ADDENDUM NO. 3

SUBJECT: Addendum No. 3 – Magnolia Avenue Streetscape Project

PROJECT NO.: 15A-R-0584 & 16A-R-0609

PROJECT No.	16A-R-0609	YEAR	2017	SHEET No.	27
REVISIONS					
No.	DATE	BY	BRIEF DESCRIPTION		
1	02-22-2018	MLK	ADDENDUM 3 - REVISED STA. 33+00

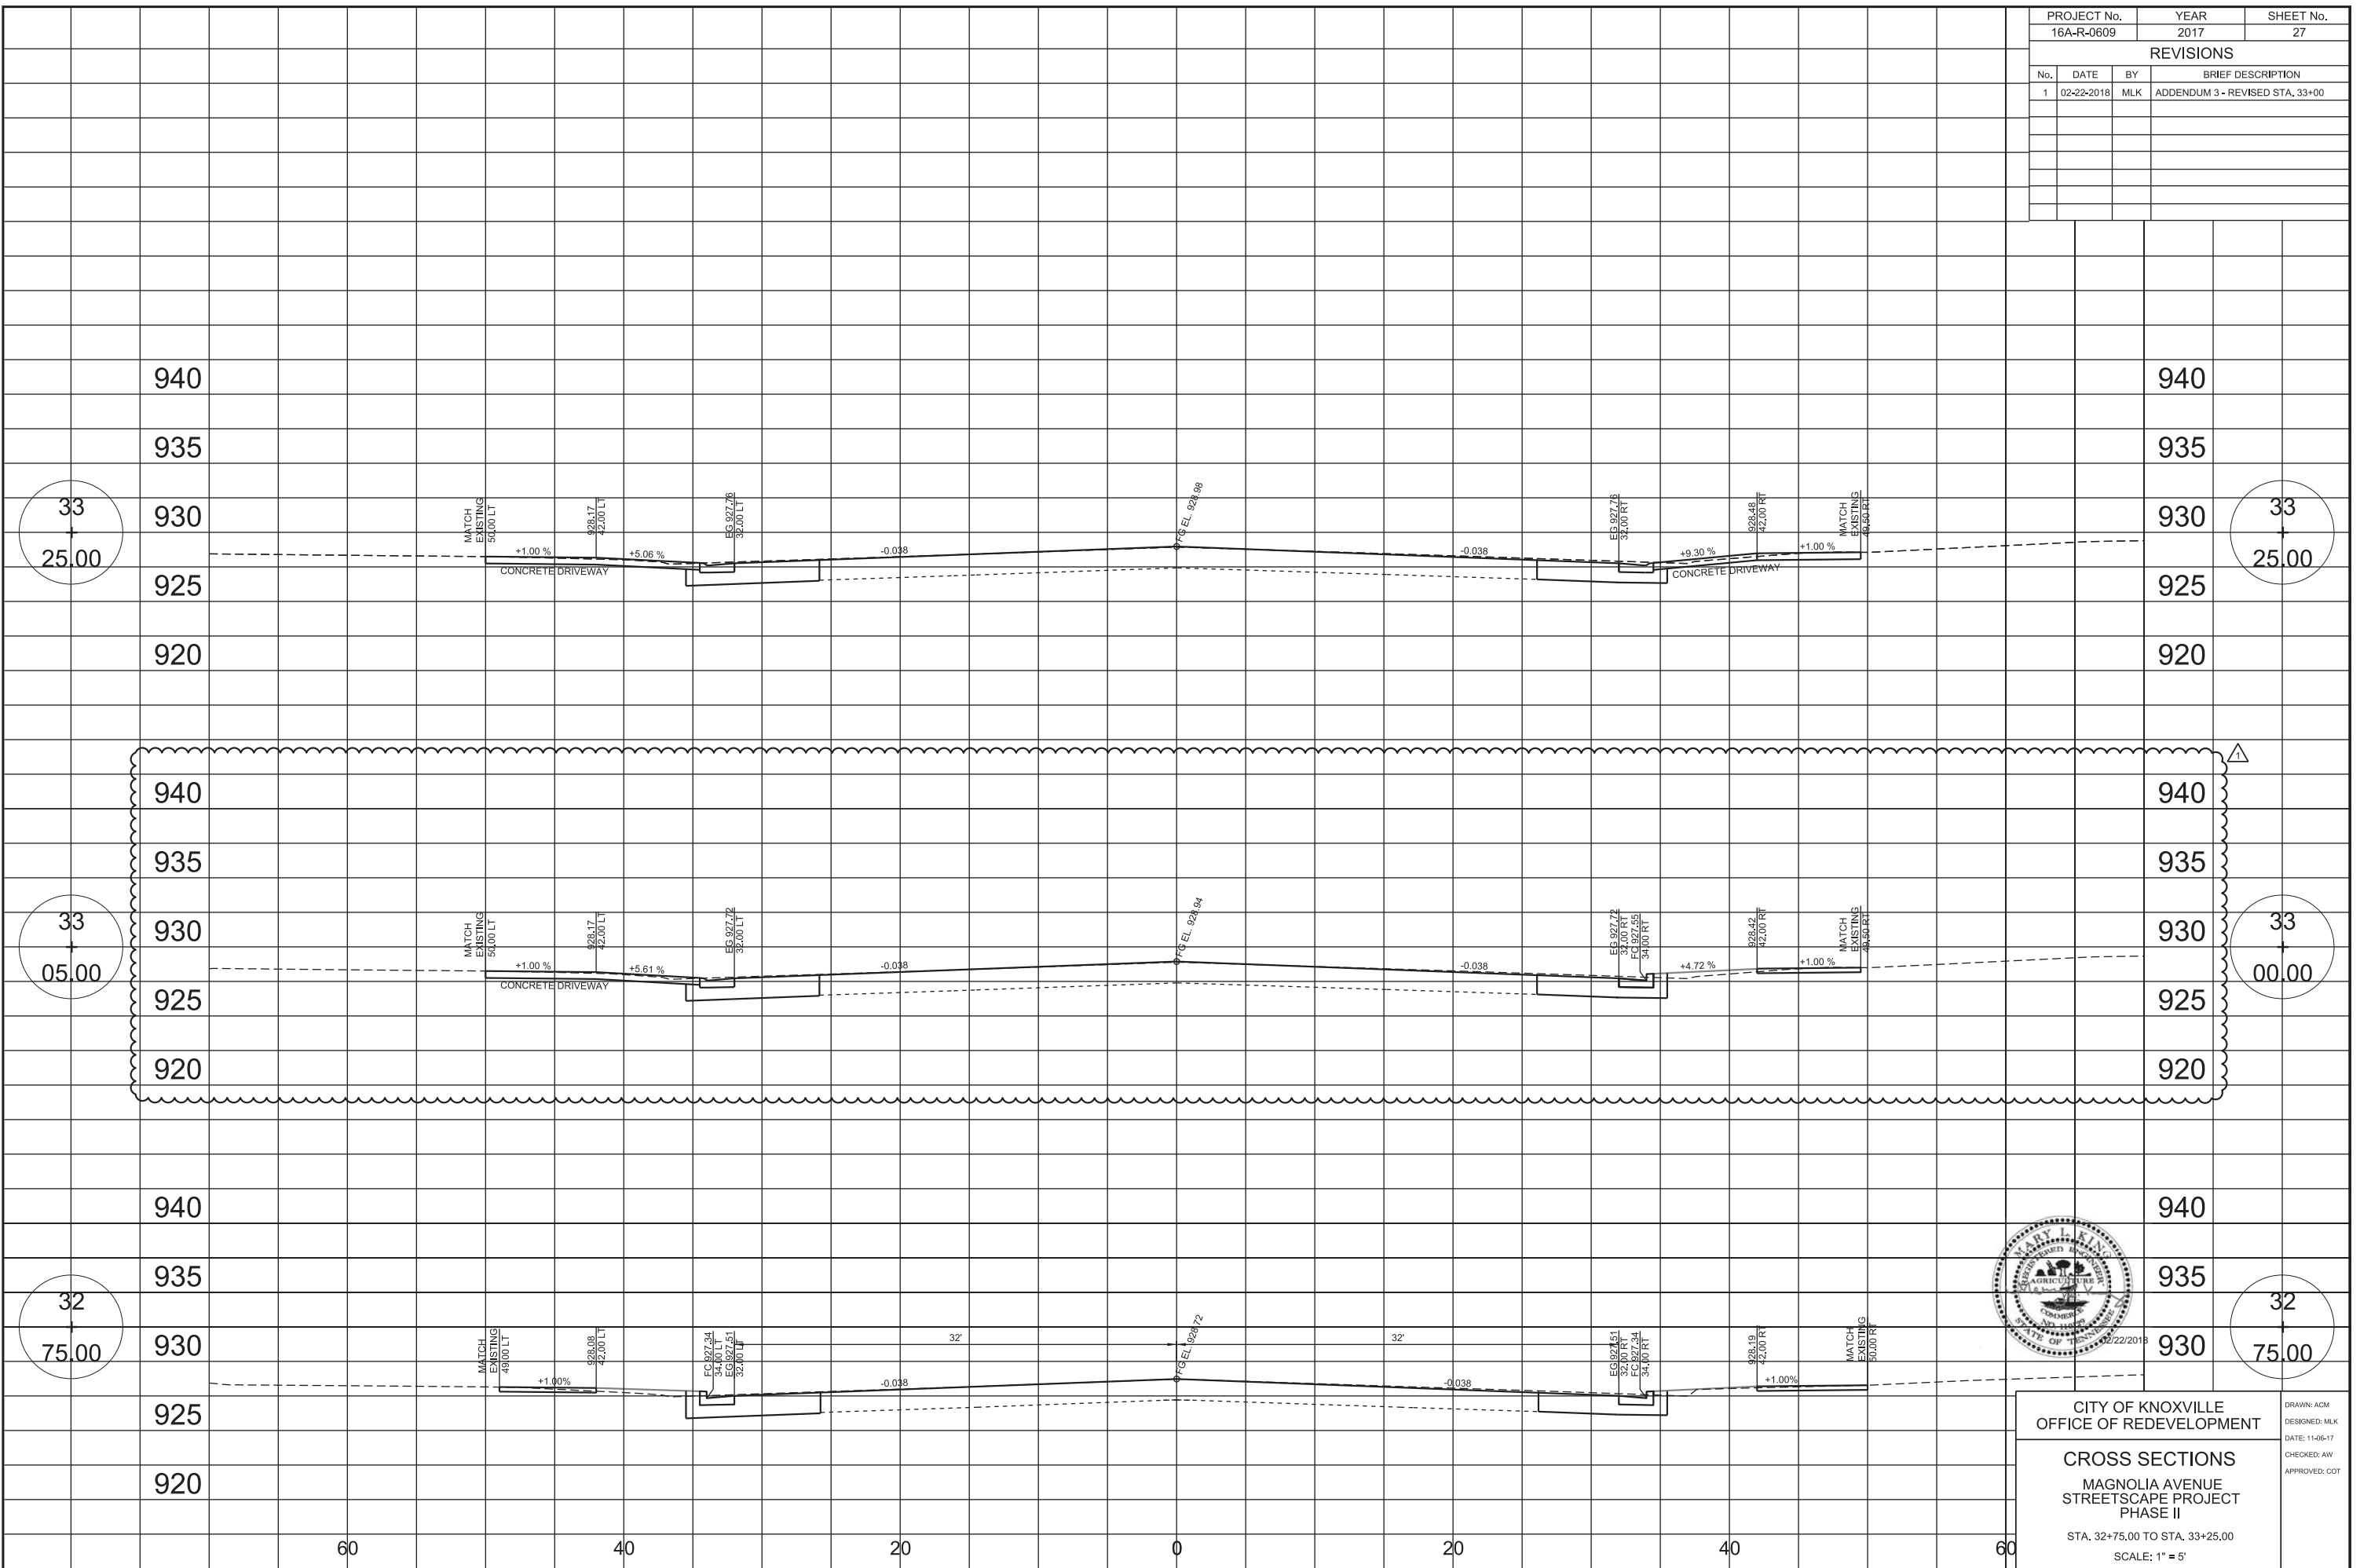
- 15.) Phase II, Sheet 6 – Displayed sanitary linework
- 16.) Phase II, Sheet 27 – Revised cross section at Sta. 33+00
